Land Development Regulations  
Major Development Application  
Major Development  
Submittal Review Comments No. 2

Permit No.: **PZ23-0008**

Project Name: **SUBMITTAL NO. 2 REVIEW  
PROPOSED COMMERCIAL DEVELOPMENT  
METAL ROLL FORMING COMMERCIAL FACILITY  
25870-000-000: 909 WEST STREET, PARKER, FLORIDA 32404  
25869-000-000: 4623 EAST 2ND STREET, PARKER, FLORIDA 32404  
25838-000-000: 4610 EAST HIGHWAY 98 BUSINESS**

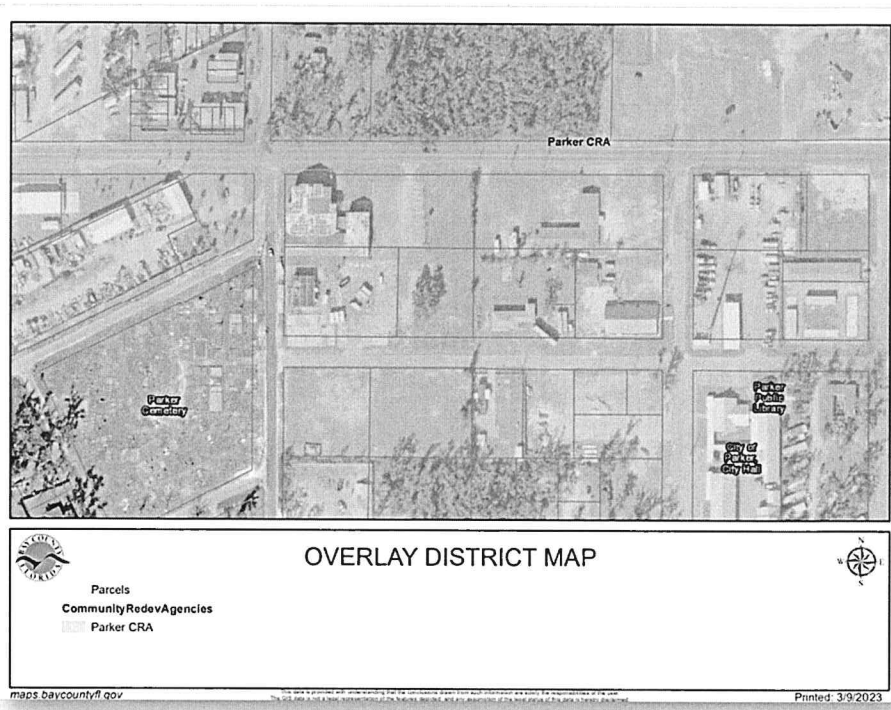
24. Contour Elevations:	<p>25871-000-000 – Contours are relatively flat on this parcel at around 20 feet, the north and west borders to slope to 16 to 17 feet as you reach the roadways, East 2nd Street and West Street. 25872-000-000 – Contours gently slope from 21 feet from the front boundary southeastward to 18 feet.</p>
